UNITED STATES PATENT AND TRADEMARK OFFICE

10/510,488

Office Action Summary	Application No. 10/510,488	Applicant(s) BROWNING, JAMES	
	Examiner CATHERINE E. BURK	Art Unit 4185

DETAILED ACTION

Figure 1 Modified version of figure 13 from Kovac showing patch (39) and designating base ends of fixing zones.

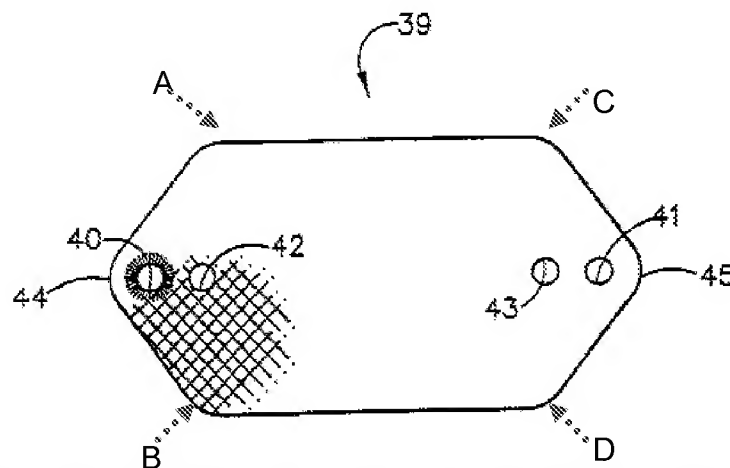
15. Regarding claim 8; Kovac discloses an embodiment of the invention comprising pointed first ends (fig. 13, elements 44 and 45) and base portions shown in figure 1 below (dotted arrows and letters were added by examiner for clarity) as imaginary lines between angles A and B, and angles C and D with longitudinal edges extending there between.

Kovac does not disclose wherein the longitudinal edges are notched to provide a row of projections extending outward from the longitudinal edges.

However, Fierro discloses a sling for treating urinary incontinence comprising a band (2) with middle part (3) containing a pad (6) (supporting zone) and two end parts (4) (fixing zones). In one embodiment, the end part (4) comprises a notched (projection) longitudinal edge extending between a pointed first end and a base (view fig. 8).
